A RESOLUTION APPROVING THE MINOR MODIFICATION TO THE
WINMORE CONDITIONAL USE PERMIT FOR A "DAYCARE FACILITY"
AT 515 EAST WINMORE AVENUE
Resolution No. 53/2009-10

STAFF REPORT

PROJECT: Minor Modification to Winmore CUP for "Daycare Facility" at 515 East Winmore Avenue

EXTERIOR
ELEVATIONS

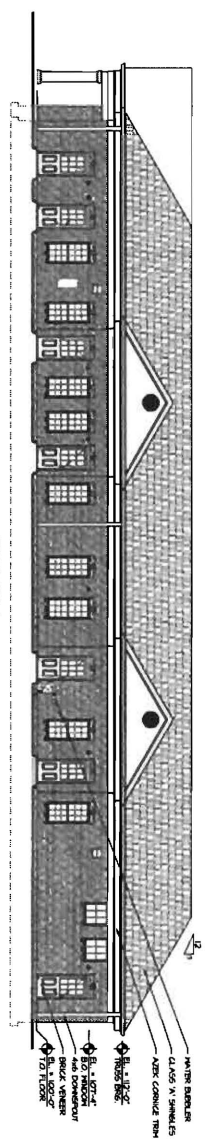
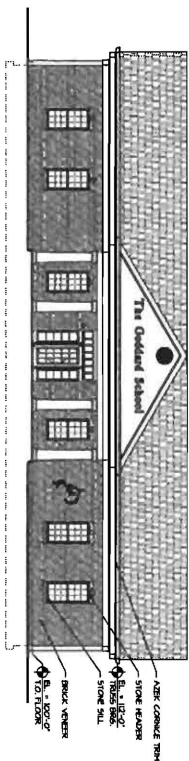
PB	15. The applicant has not shown attention to appropriate building orientation, building style, location of windows, etc. (see previous Planning Board recommendations to the applicant).
PB	16. More generally, the applicant seems to be intent on placing a pre-designed building on the site that is not appropriate for that location (or for Carrboro).
PB	17. Recommends that the applicant provide covered bicycle parking spaces near the front entrance of the building, instead of or in addition to the uncovered spaces provided near the dumpster at the rear of the property. The town's Comprehensive Bicycle Transportation Plan recommends that employers encourage bicycling by providing bicycle parking. Bicycle parking should be "clearly visible from the entrance it serves" and "should be sheltered when possible."
PB	18. This development was presented as a response to the need for affordable daycare in Carrboro. However, the applicant has not presented information to show that this project would be an affordable option for daycare. The applicant has not responded satisfactorily to the Planning Board's suggestion to provide scholarships or other financial assistance for students, except to note that this decision would be up to the franchisee. However, the franchisee has not provided comments.

Clinton moved and Carnahan seconded that the Planning Board recommends approval of the modification to the Winmore VMU conditional use permit with Building Option 1 as shown on the attached sheet, and commends the applicant for its commitment to environmentally conscious building through the items identified on the Winmore Green Builder Worksheet also attached.

Per subsequent meetings with The Planning Board, the revised building will be one-story and not have dormers on the front façade (**Attachment H**). The building will still be constructed entirely of reddish brown brick and a majority of the accents (windows, trim, gutters etc.) will be white.
